OMAHA PUBLIC POWER DISTRICT

FORT CALHOUN STATION, UNIT NO. 1

AMENDMENT TO FACILITY OPERATING LICENSE

Amendment No. 161
License No. DPR-40

Figure
2-1A

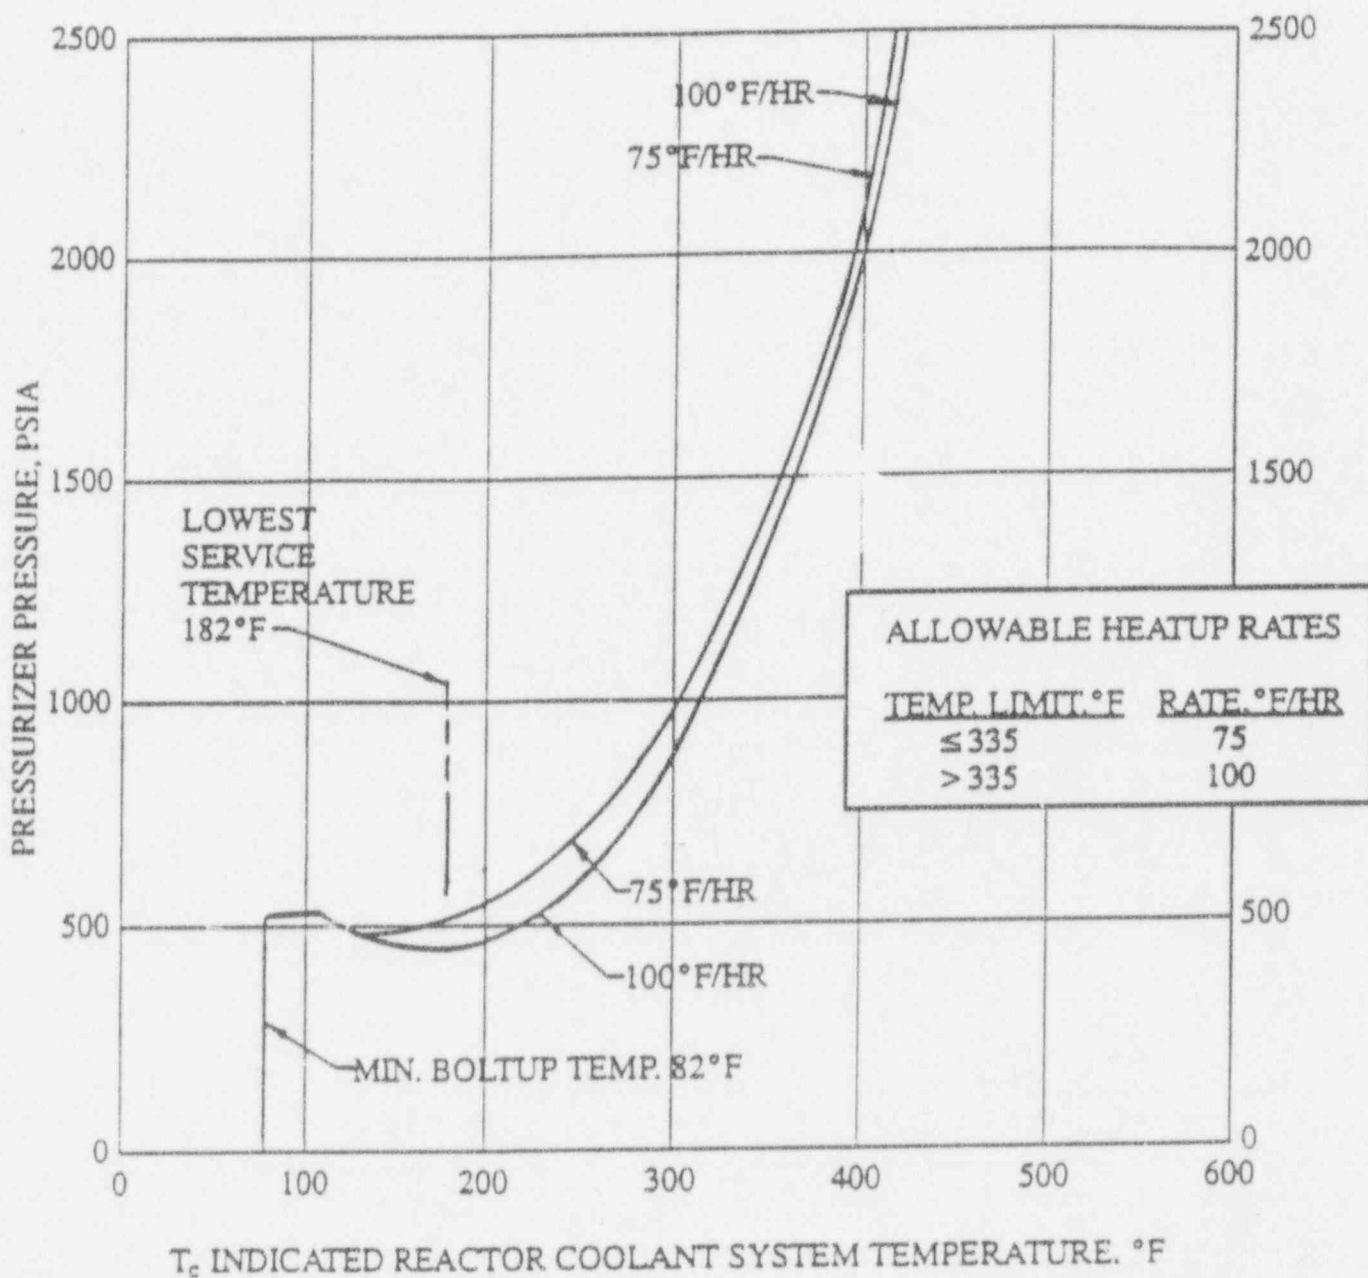
The reactor coolant pressure shall be limited during plant operation in accordance with Figure 2-1A and 2-1B and as follows:

- (1) Allowable combinations of pressure and temperature (T_c) for a specific heatup rate shall be below and to the right of the applicable limit lines as shown on Figure 2-1A.

The limit lines in Figures 2-1A and 2-1B are based on the following:

- A. Heatup and Cooldown Curves - From Section III of the ASME Code, Appendix G-2215.

Figure
2-1B

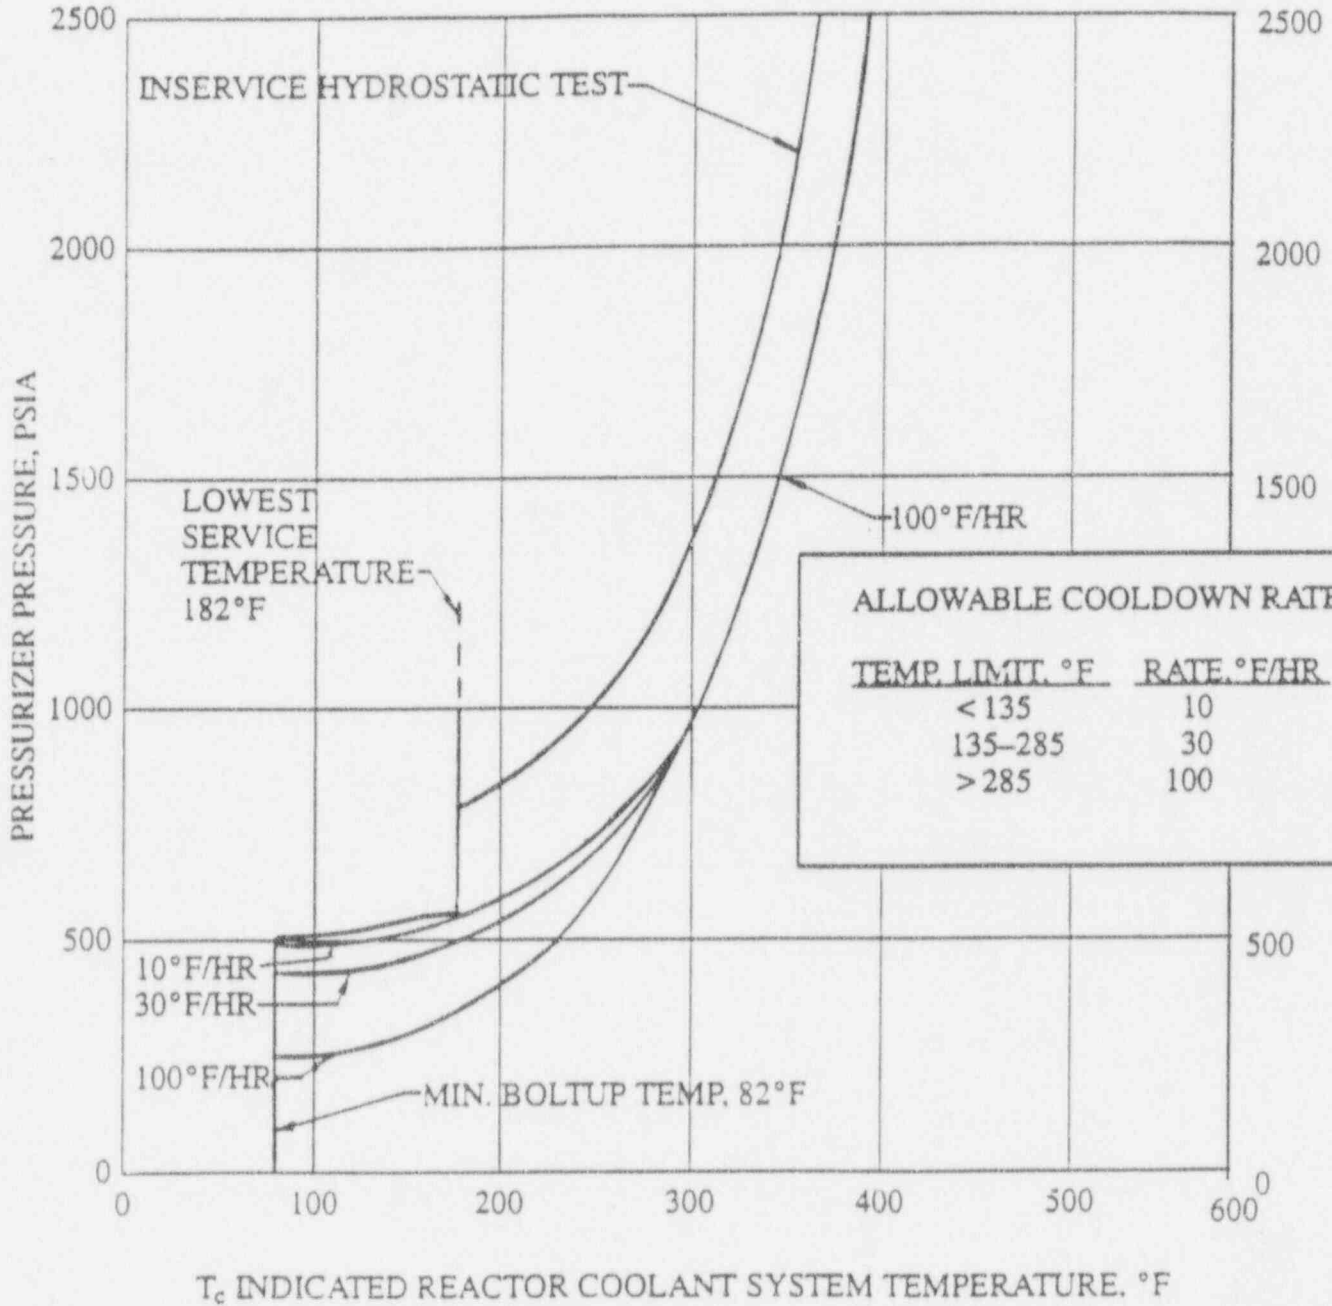
- (2) Allowable combinations of pressure and temperature (T_c) for a specific cooldown rate shall be below and to the right of the applicable limit lines as shown on Figures 2-1B.

- E. The temperature at which the heatup and cooldown rates change in Figures 2-1A and 2-1B reflects the point at which the most limiting heatup and cooldown rates with respect to the inlet temperature (T_i) change.

Figure
2-3

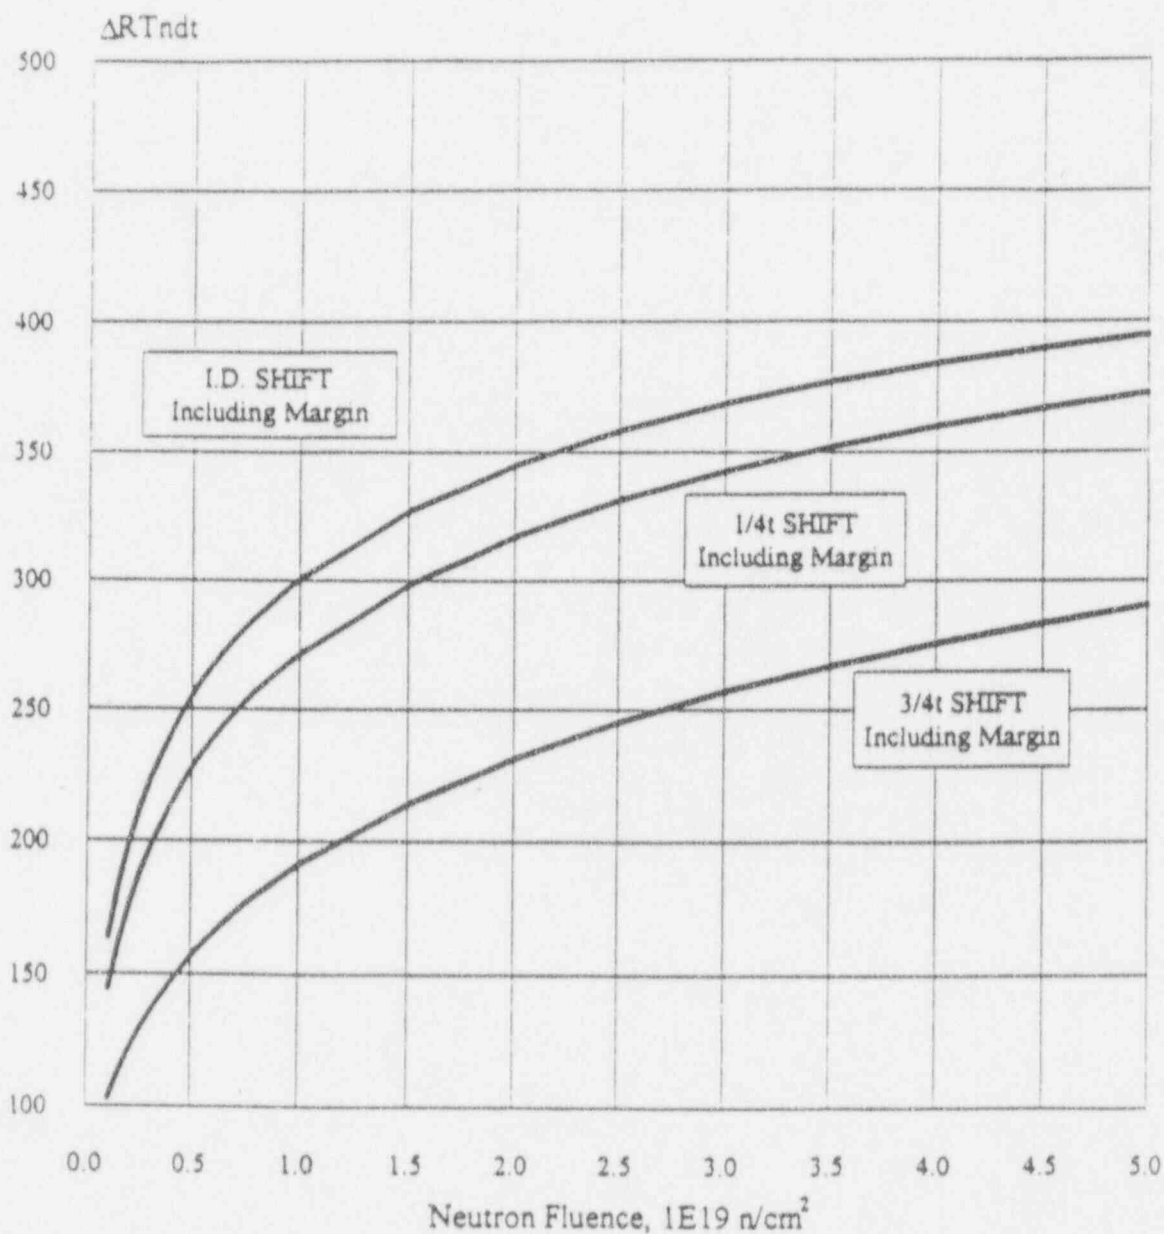
- (a) The curve in Figure 2-3 shall be used to predict the increase in transition temperature based on integrated fast neutron flux. If measurements on the irradiation specimens indicate a deviation from this curve, a new curve shall be constructed.

- (b) The limit line on the figures shall be updated for a new integrated power period as follows: the total integrated reactor thermal power from startup to the end of the new period shall be converted to an equivalent integrated fast neutron exposure ($E_{\geq 1 \text{ MeV}}$). The predicted transition temperature shift to the end of the new period shall then be obtained from Figure 2-3.
